# Adams School Redevelopment

## **Addendum No. 2** to Contract Documents

March 23, 2012

**FOUNDATION PLAN- BUILDING A**

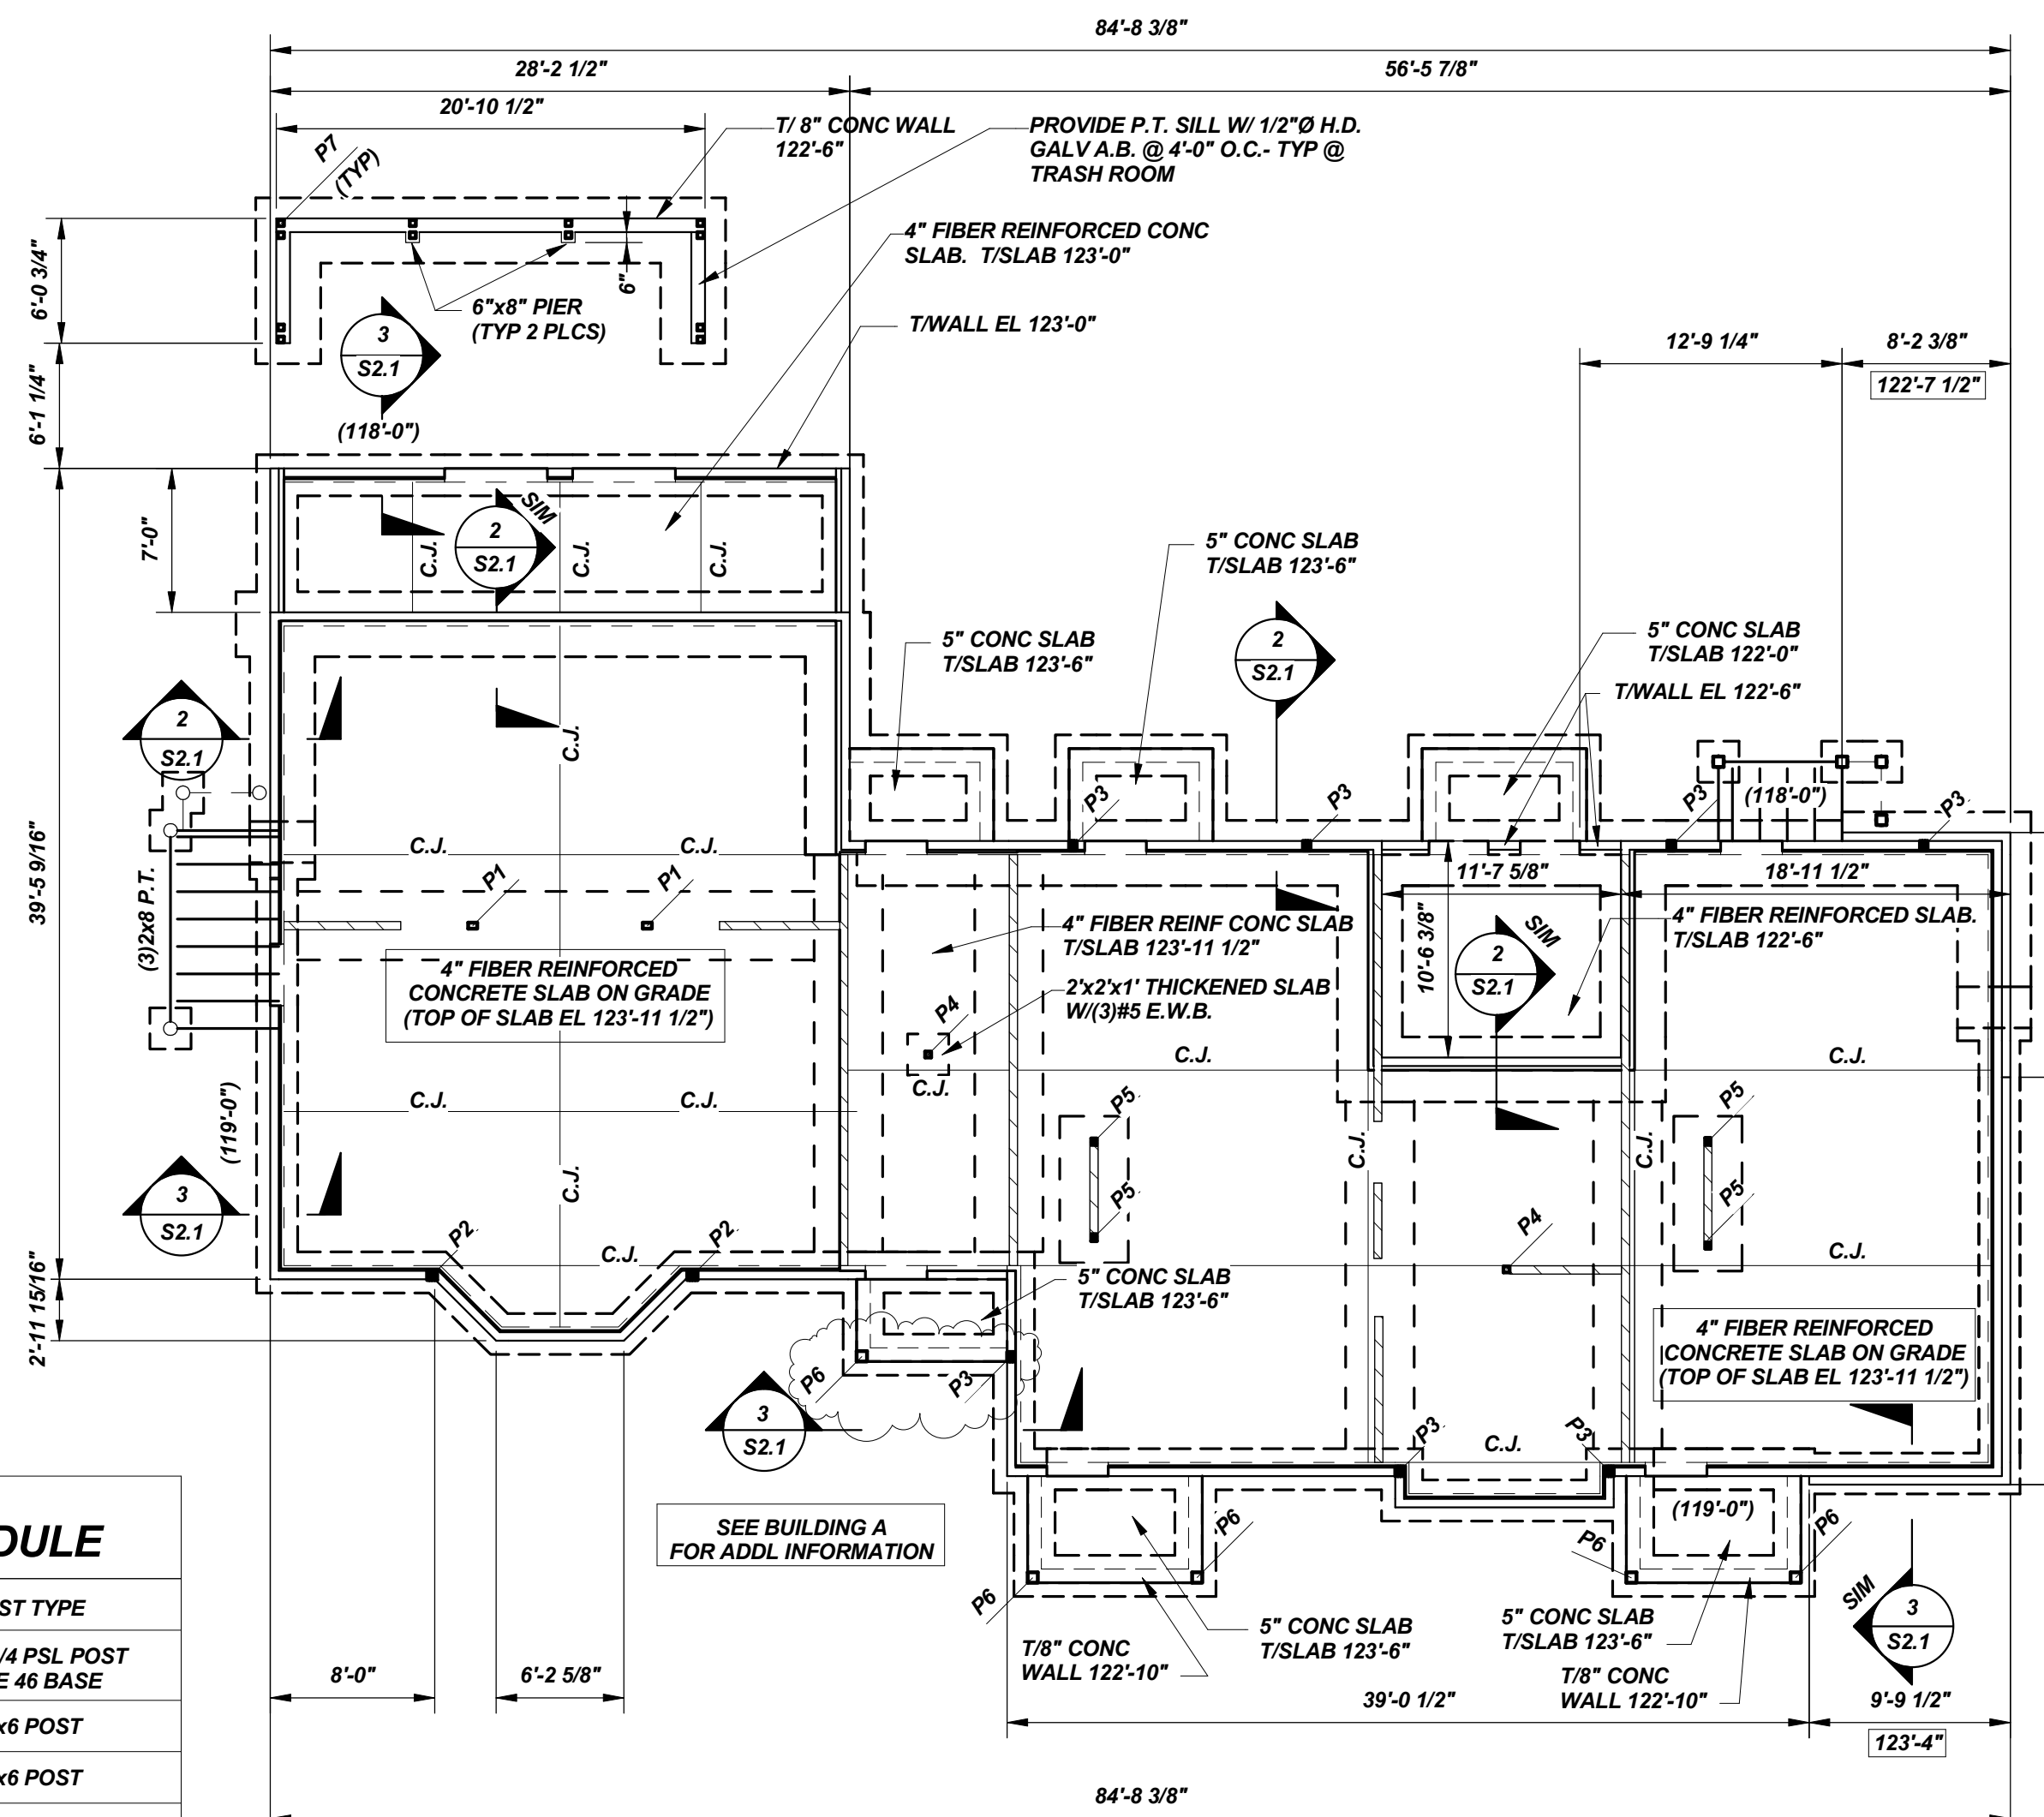
- Sheet S1.1: MODIFY as shown on attached S1.1/Addendum 2.  
Sheet S1.2: MODIFY as shown on attached S1.2/Addendum 2.  
Sheet S1.3: MODIFY as shown on attached S1.3/Addendum 2.

**SKS-1**  
INDICATED REVISIONS-PAGE 1 OF 3
